DEVELOPMENT APPLICATION NO: DA19/0875

URBIS RESPONSE TO PENRITH CITY COUNCIL REQUEST FOR ADDITIONAL INFORMATION – 27TH APRIL 2020

Response to RFI Relating to Visual Impacts

NEPEAN GARDENS, WALLACIA, NSW

VP A : 115 PARK ROAD, LOOKING NORTH | 3D MODEL - FULL MONUMENTAL WITH 1500MM HEADSTONE (WITH VEGETATION AT 5 YEARS)

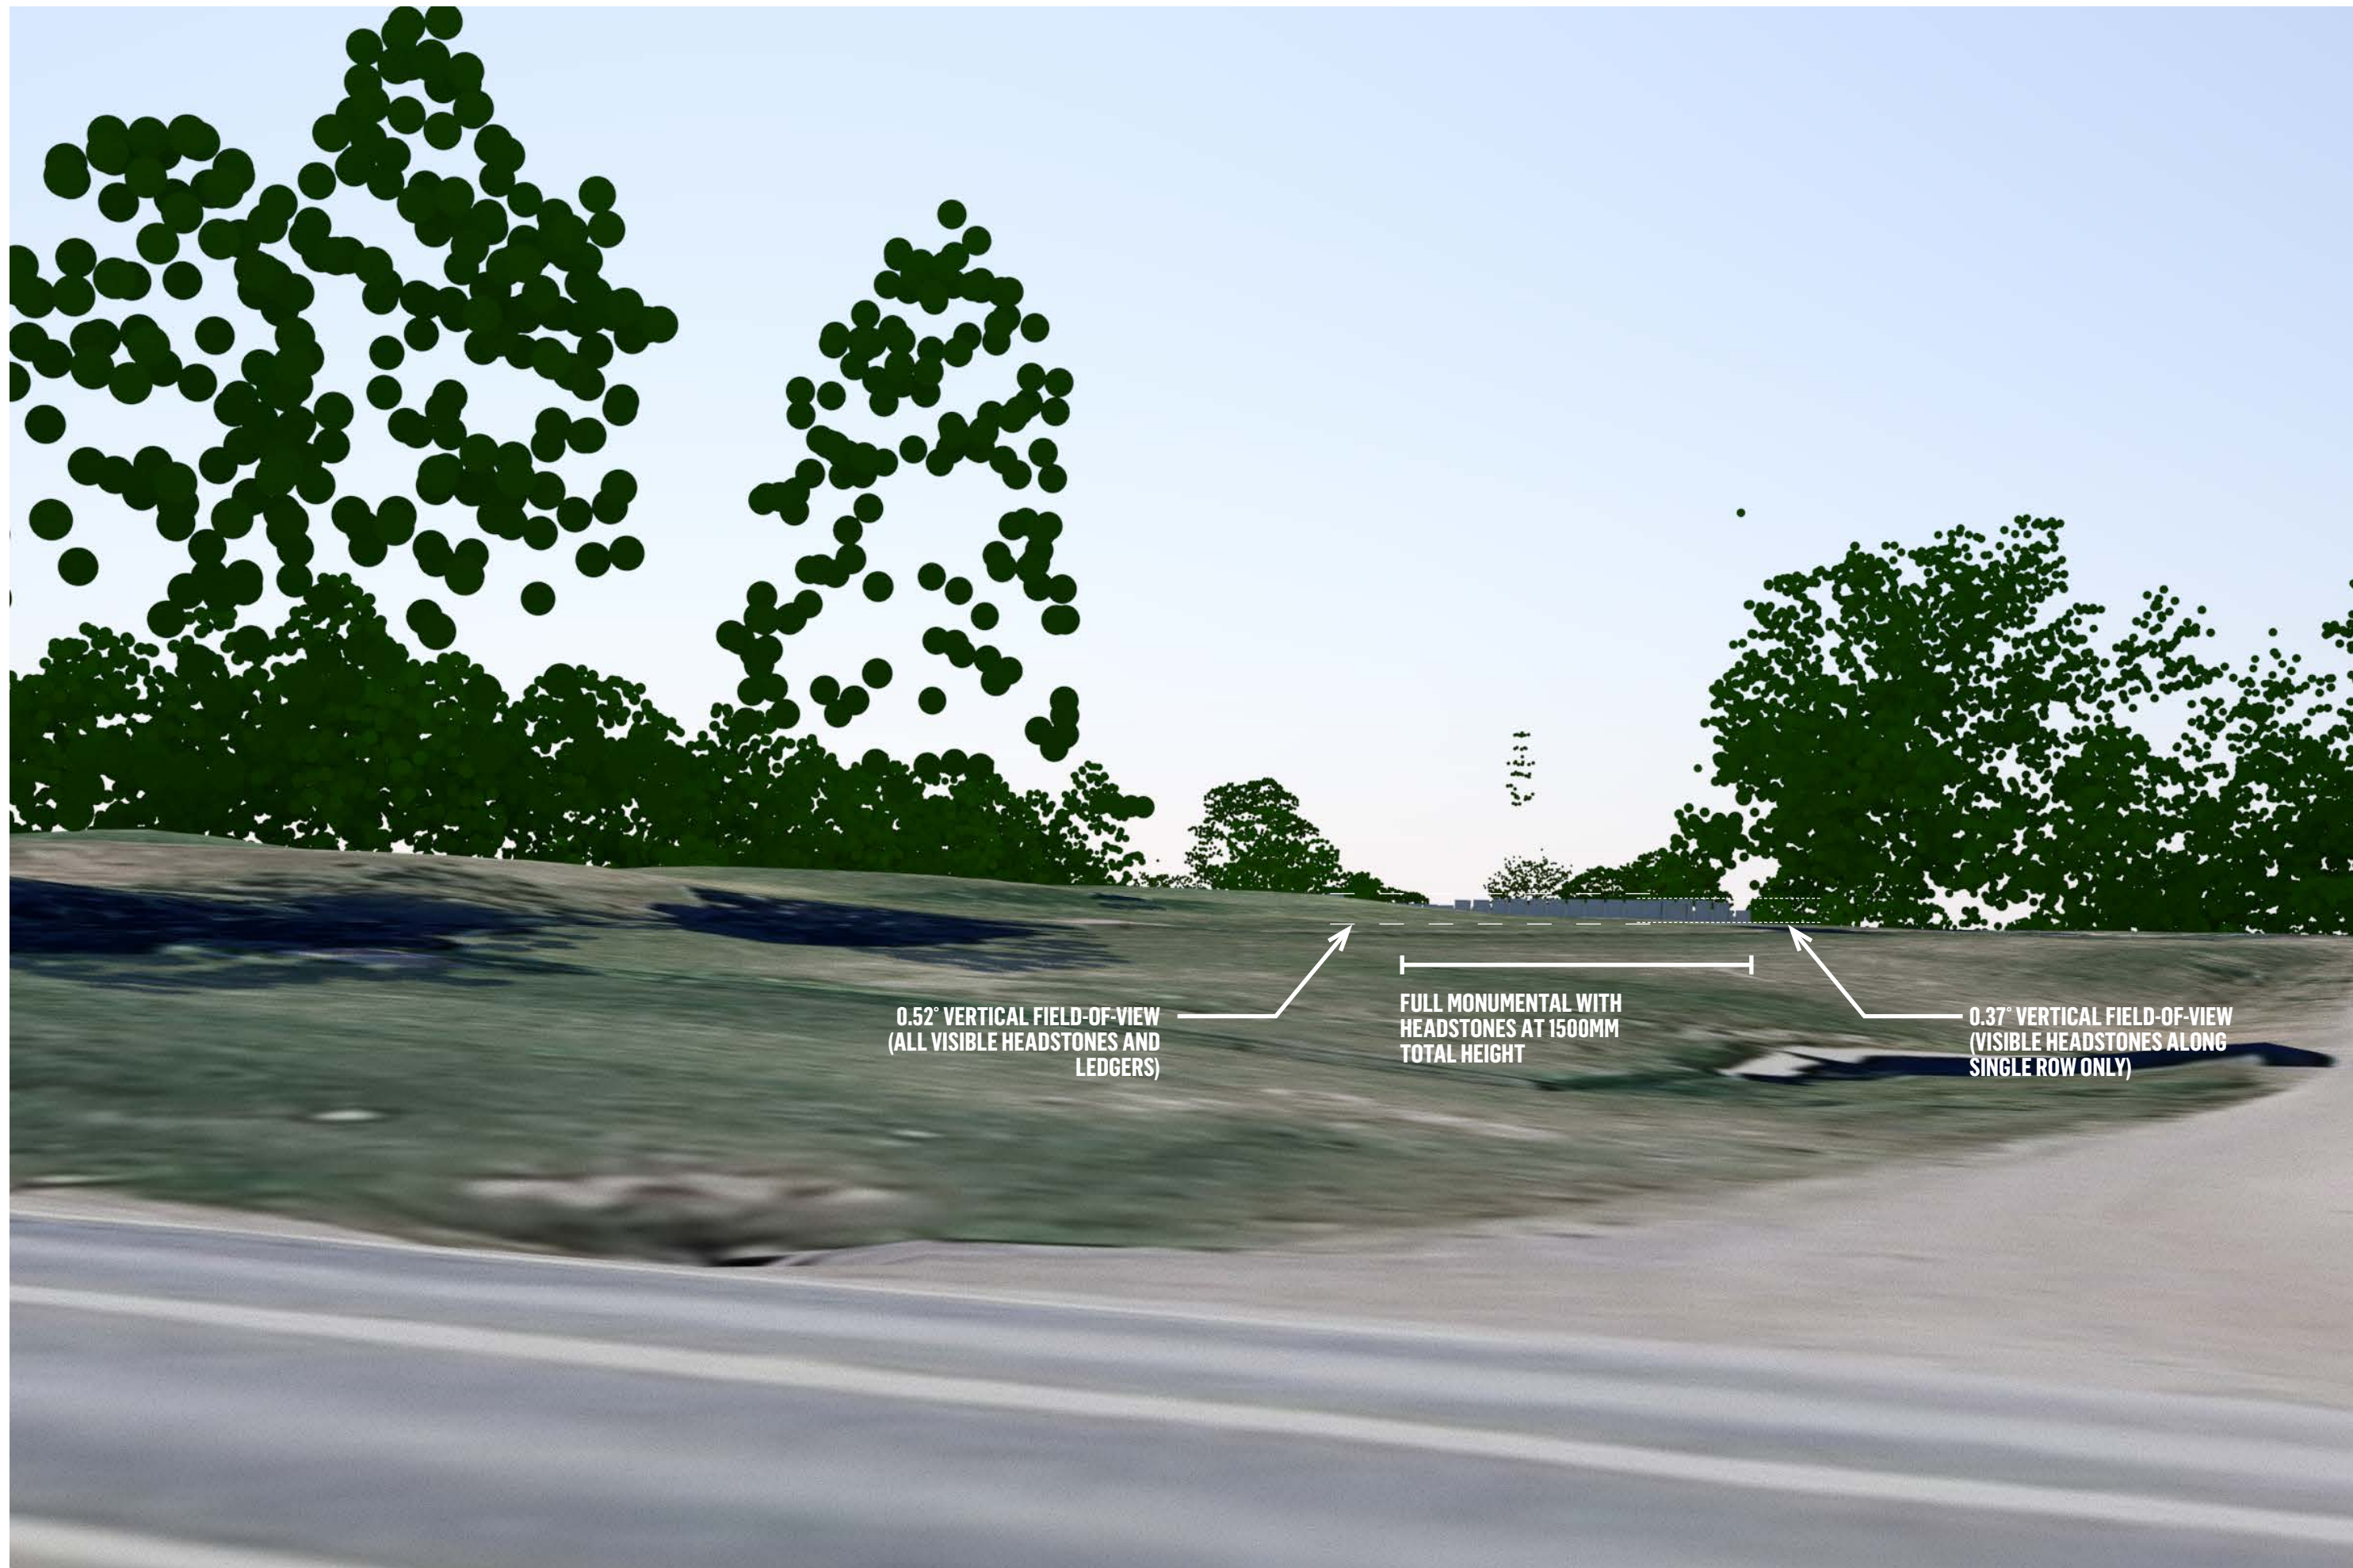
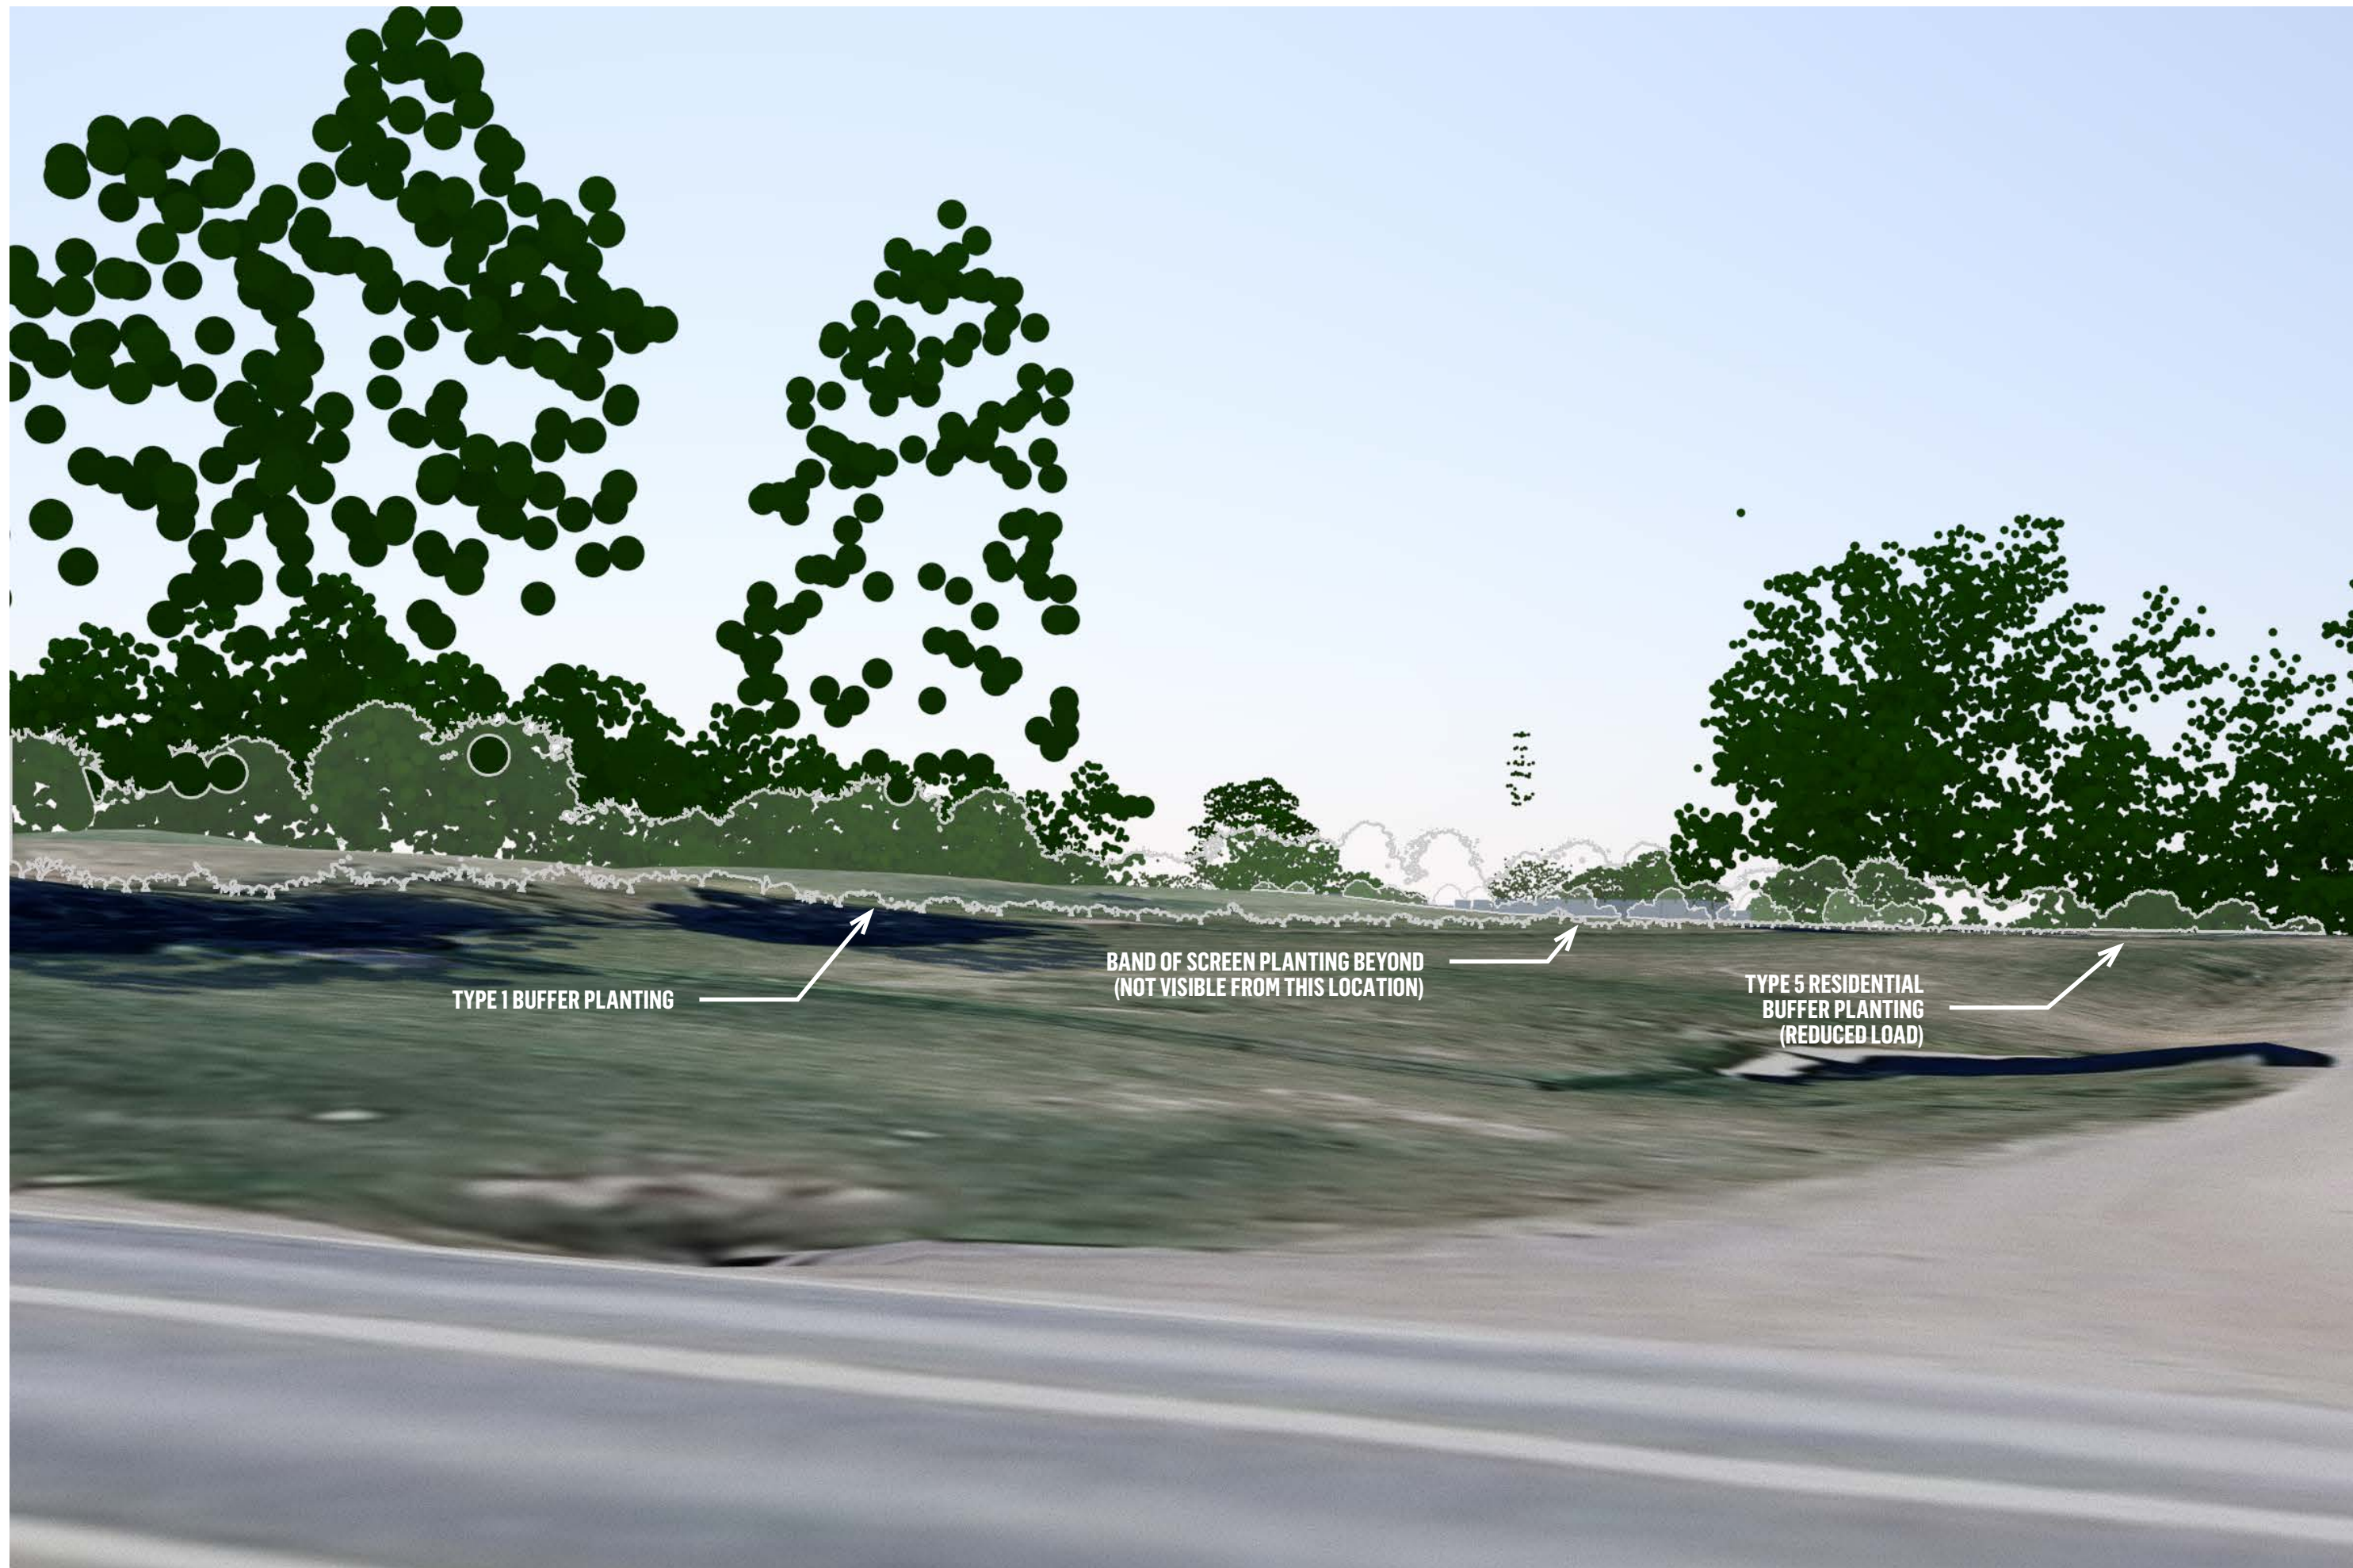
(h) The proposal for Type 3 - 1.5m high memorial head stones is likely to impact poorly on views from neighboring rural residential properties. A response is requested as to why memorial headstones should not be limited in height to 600-800mm, so as to be less visible. The impact of the proposal for Type 4 - Full monumental installations needs to be assessed and in this regard, further detail is to be provided as to the allowable dimensions and locations for this typology. A view analysis or montage may be required.

- VP A – 0.19° vs 0.52°
- VP B – 0.53° vs 1.14°
- VP C – 0.76° vs 1.23°

In all views, the buffer landscaping is highly effective at ameliorating views from surrounding areas. Given the headstones are only 1.5 m in height, buffer planting proximate to viewing location is highly effective in screening views within a relatively short period of time. Post planting, the landscape will gradually reduce views of the monuments. The computer simulations demonstrate that after 5 years, the landscaping will be of a height to effectively screen views to the tops of the monuments.
